Please add additional information to P/2021/0172 and P/2021/0173

Subject: Fwd: Re: Scanned document from HP ePrint user

Please see below response to the queries that were raised.

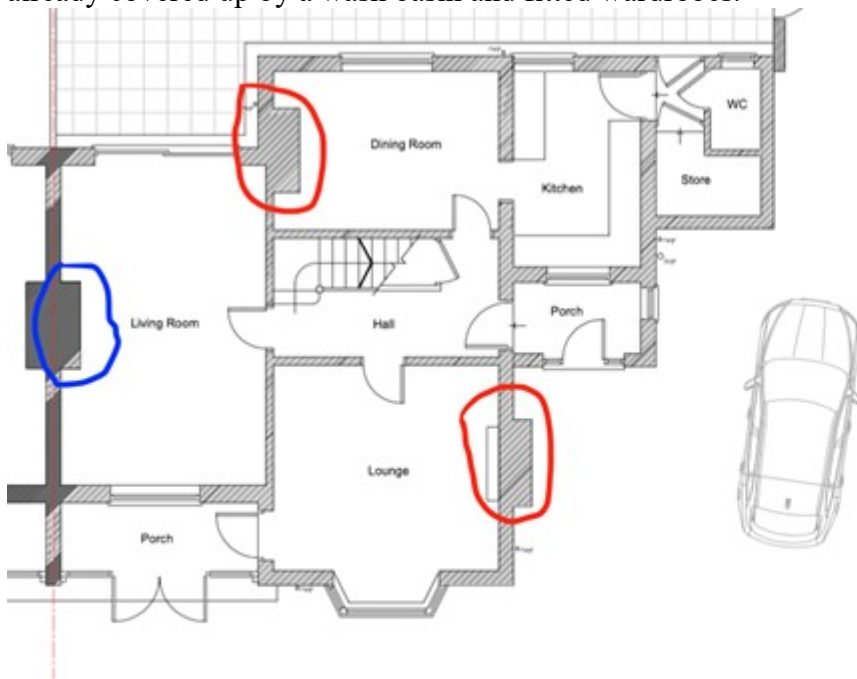
Floor of the store room (see picture below) - we propose to raise the floor, adding insulation, making it the same level as the floor in the exterior porch and downstairs bathroom

Existing Ground
Floor Plan
1:50

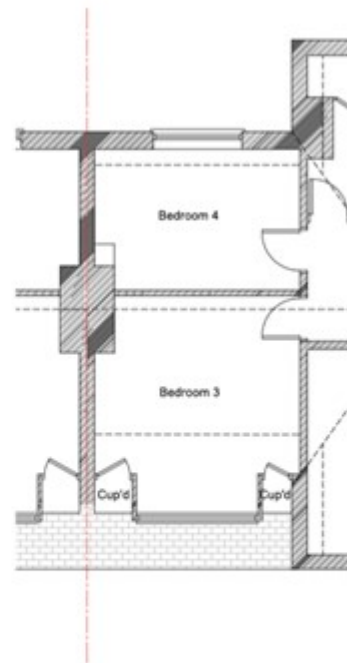
Fireplaces - The fireplaces being reinstated are shown circled in Red - in the Dining Room (currently boarded over with a gas fire) and the Lounge (currently has a gas fire in situ). The fireplace circled in blue in the Living Room we are proposing to cover up, whilst the fireplace circled in yellow, in Bedroom 1 is already covered up by a wash basin and fitted wardrobes.
